1.2 73-75 KINGSWAY, GLEN WAVERLEY

AMENDMENT TO ALLOW FOR THE DEVELOPMENT AND USE OF LAND FOR A SEVEN (7) STOREY BUILDING COMPRISING FOOD AND DRINK PREMISES AND OFFICES, AND A REDUCTION IN THE CAR PARKING REQUIREMENT TO ZERO (TPA/50168/B)

EXECUTIVE SUMMARY:

East-West Section looking South provided by Applicant

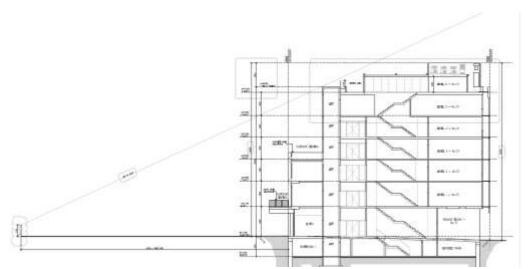
The proposed additional level will increase the maximum building height by 3.6 metres (from 23.185 to 26.795 metres). Although the building exceeds the preferred building height of 22 metres (6 stories) envisaged in the DDO12, the additional level including the open pergolas will not be highly visible from Kingsway as it is well setback from the property frontage.

The diagram shows that the sightline from the opposite side of Kingsway will be 'blocked' by the existing lift overrun and the additional level will cause minimal visual impact to the street.
